**RE:**     **Project Name:**                    CC - 57226 Barracks Remodel  
          **Project Number:**                02A7823017  
          **Project Location(s):**         Camp Carroll, Joint Base Elmendorf-Richardson, Alaska

**Mandatory Return Addendum # Eleven (11)**

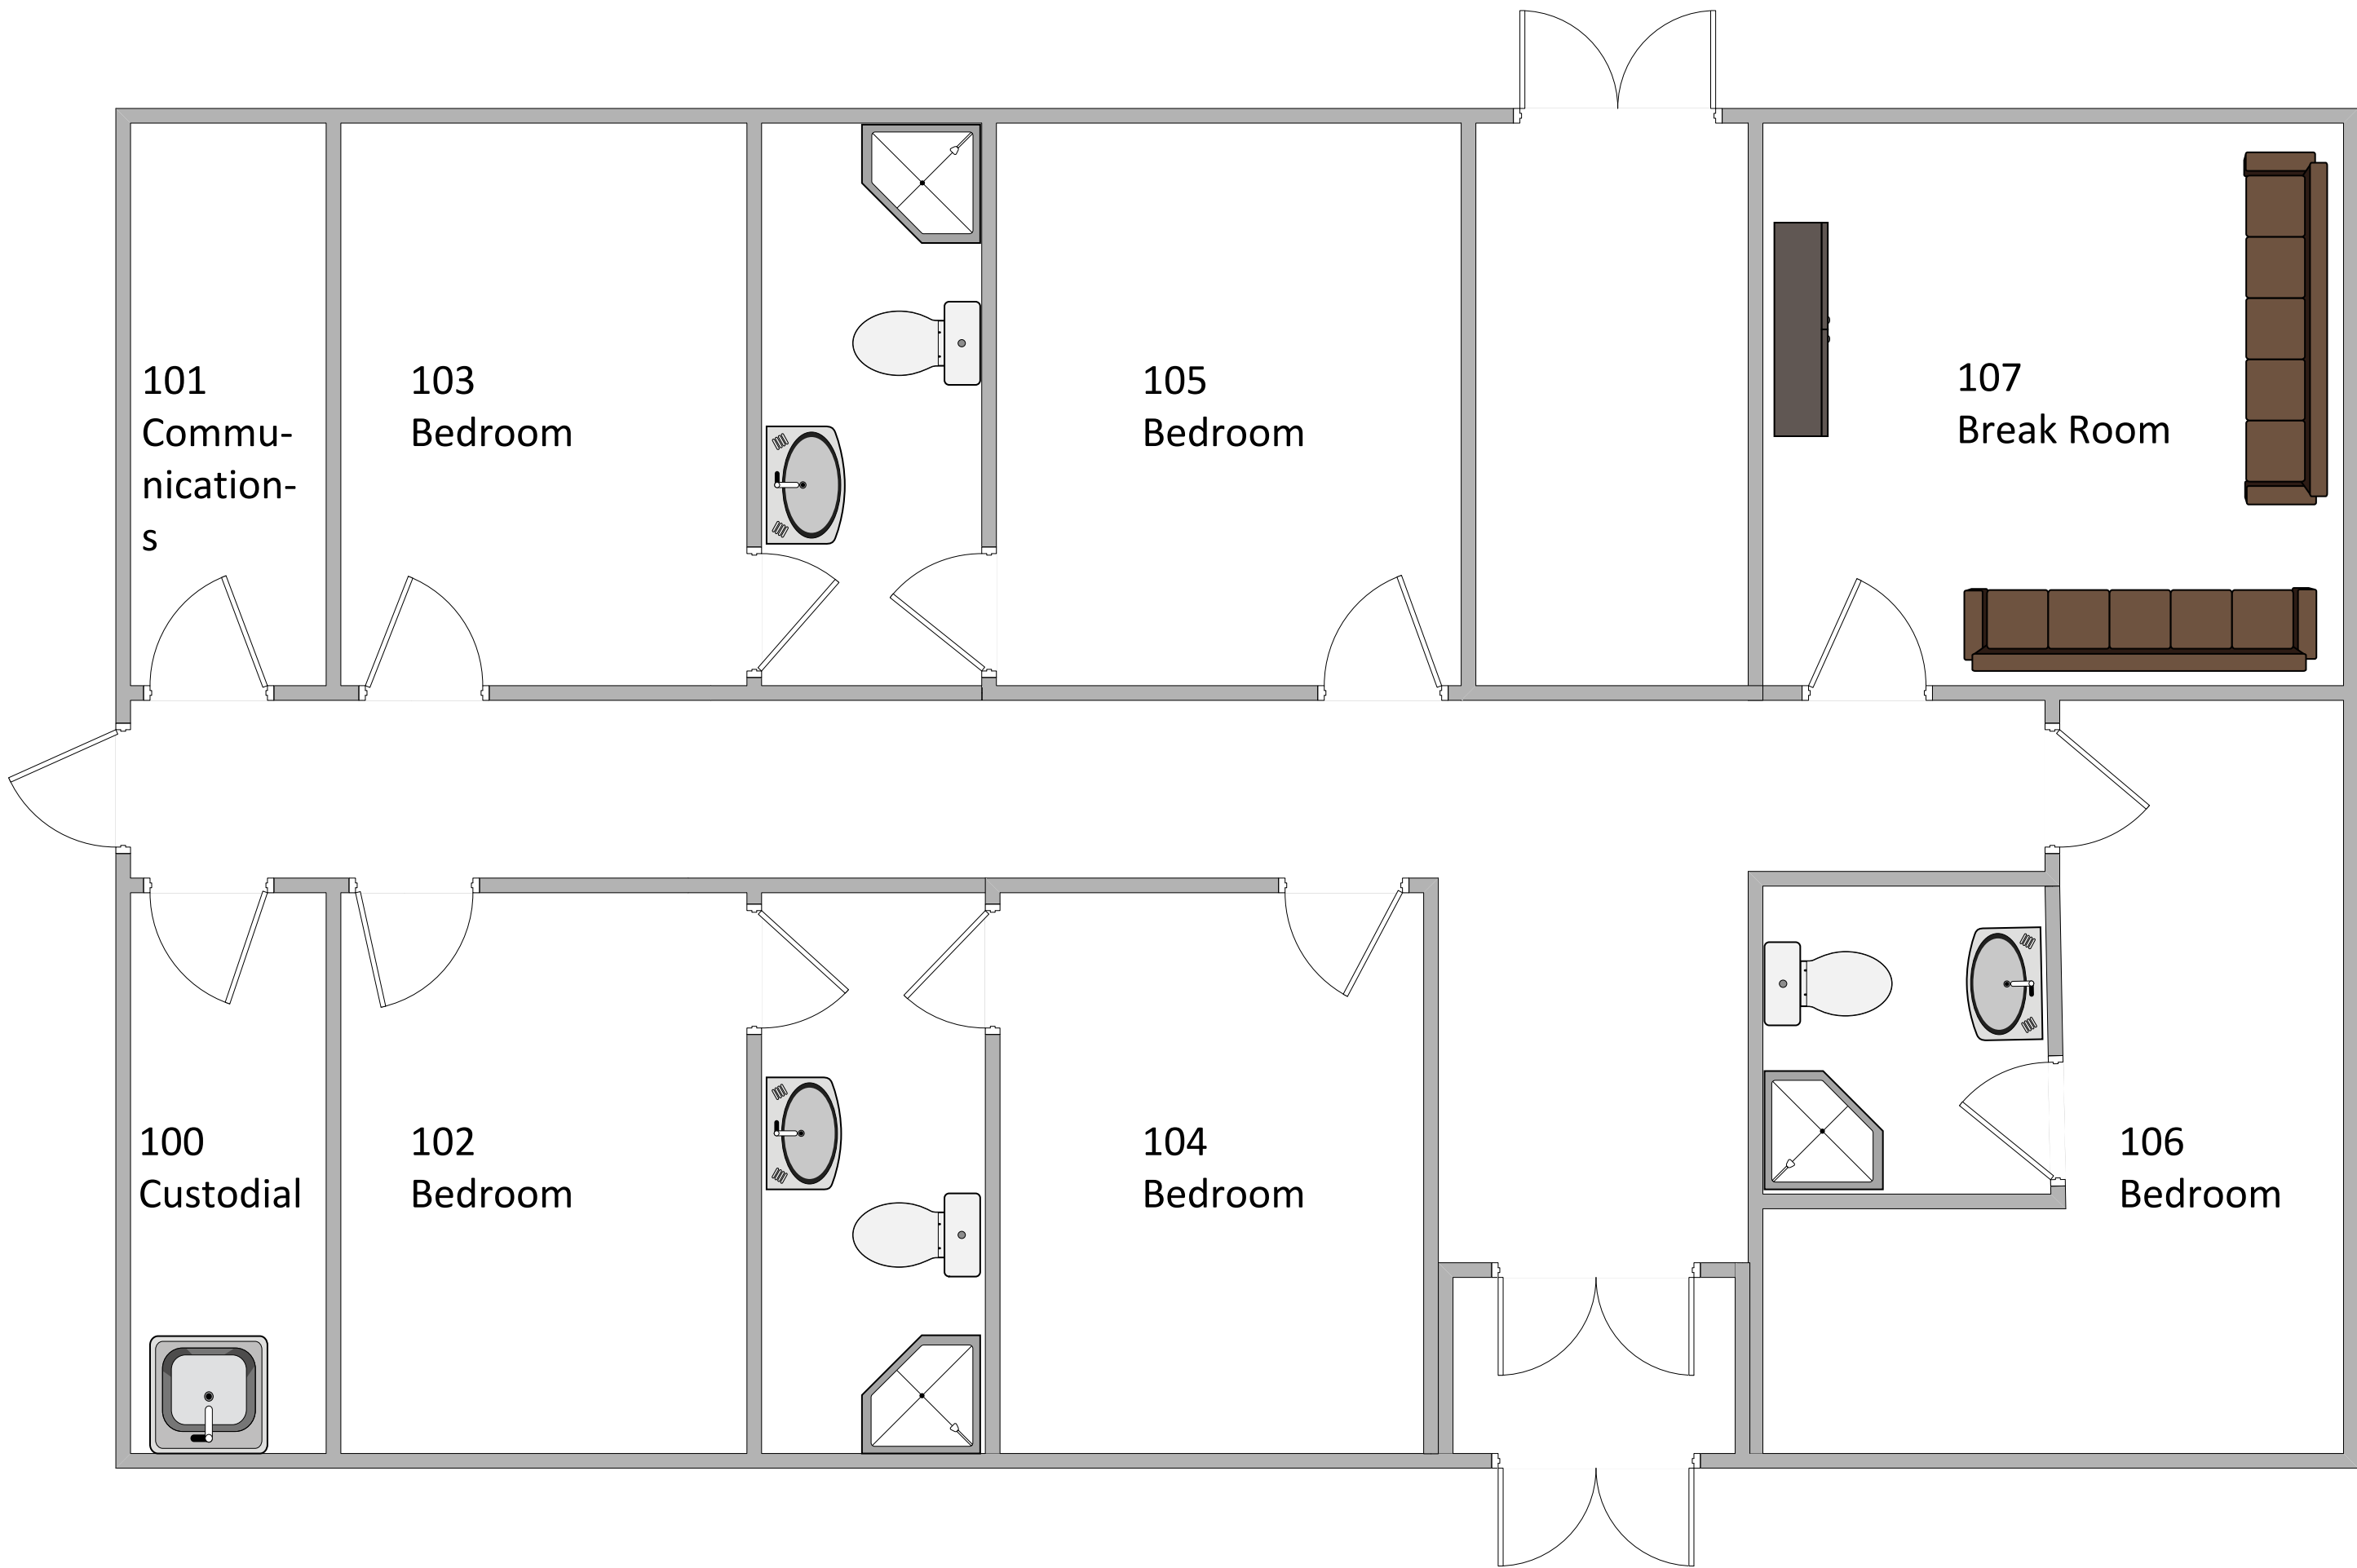
7. There are existing room signs but no requirement for new signage. Will any new signs be required for this project and if yes can a sign schedule be provided?
  - A. Yes. New signs will need to be provided. Dimensions, font size, and coloring shall match existing and will be pre-approved by the project manager. Signage locations will be pre-approved by the project manager. Please see page three of this addendum for signage contents and location assignment.
